ATLANTIC CROSSING

DATE:	ISSUE / REVISIONS:
06.18.2013	Site Plan Submittal
09.17.2013	Response to Staff Comments
10.29.2013	10/18 Staff Response
11.14.2014	Response 2.12.14 Comments
04.21.2017	Settlement Modification
07.19.2018	Arch. Elevation Revisions
08.06.2019	Class II Modification 2019

BLDG VI ELEVATIONS

A6.4

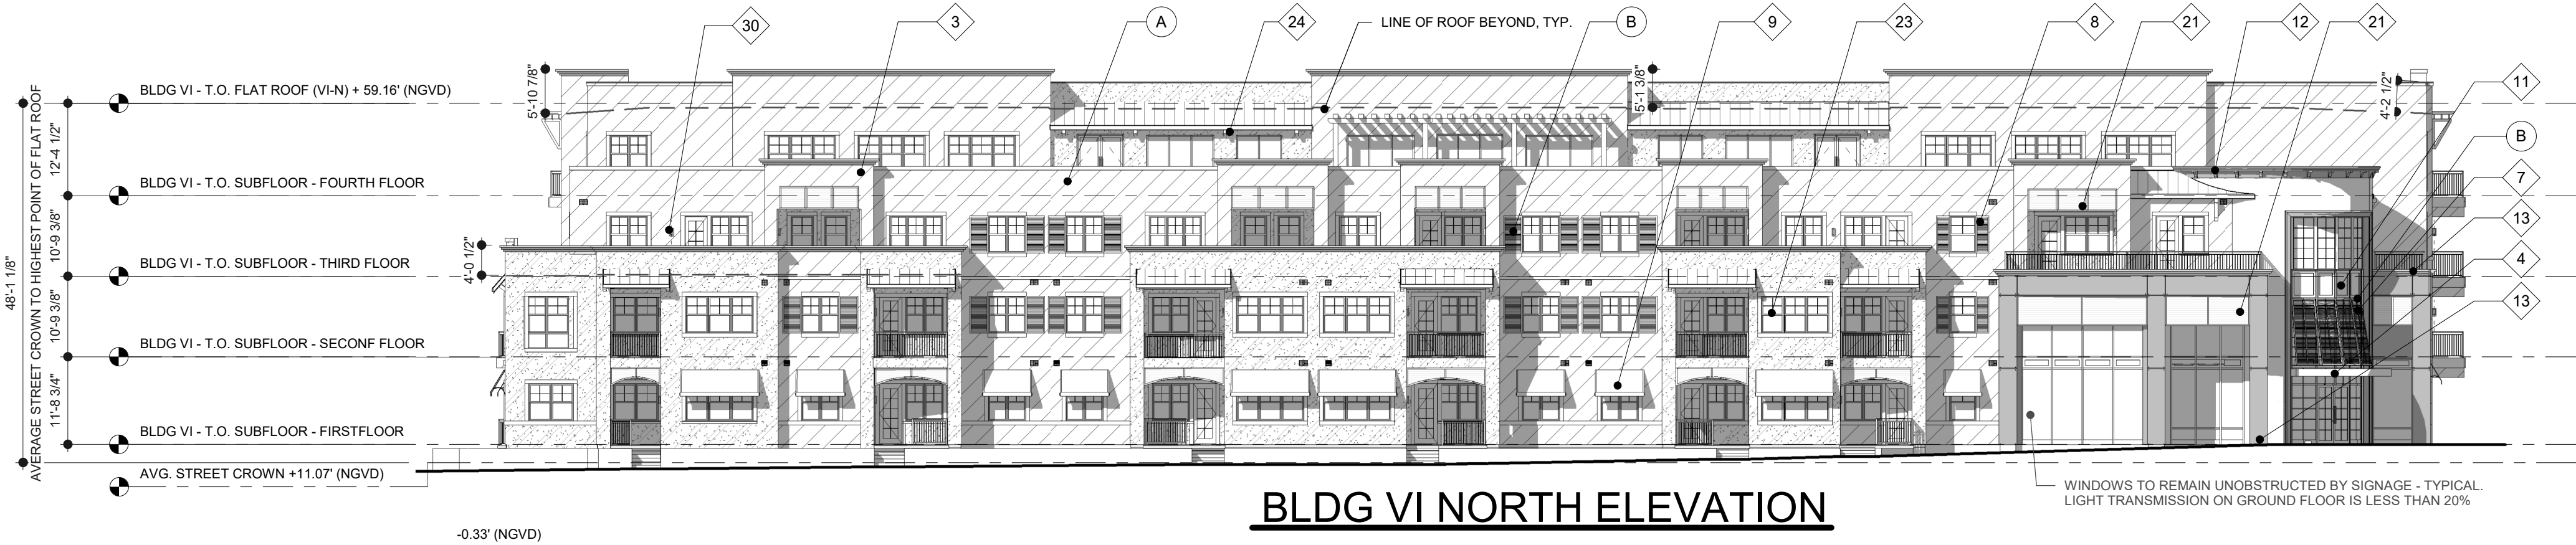
RESPONSE TO 2.12.14 STAFF COMMENTS
• WINDOWS OF THE BUSINESSES AND OFFICES REMAIN UNOBSTRUCTED BY SIGNAGE
• LIGHT TRANSMISSION FOR GROUND FLOOR GLASS AREA TO BE NO GREATER THAN 20%
• KNOX BOXES TO BE PROVIDED AT ROLL DOWN GATES
• ADJUSTED METAL AWNINGS AND ADDED MORE SHUTTERS

SETTLEMENT MODIFICATION 4.21.2017
• RELOCATED ENTRY TO PARKING GARAGE
• ADJUST EAST AND SOUTH DUE TO PARKING GARAGE ENTRY RELOCATION

ARCHITECTURAL ELEVATION REVISIONS 7.19.2018
GENERALLY REVISE ELEVATIONS TO BE MORE CONSISTENT WITH MASONRY MODERN, INCLUDING:
• STRENGTHENING PEDESTRIAN SCALE OF ENTRY TO LEASING (NORTHWEST CORNER)
• ENHANCED HORIZONTAL DETAILING AT BASE - ADDED ROOF FORMS, CONSOLIDATED COLOR, MINIMIZED TALL SLENDER VERTICAL FORMS
• ENHANCE DETAILING AT BUILDING CAP
• ENHANCE DETAILING AT BUILDING CORNERS

CLASS II MODIFICATION 8.2.2019
• ADD TRELLIS BETWEEN III & VI-S
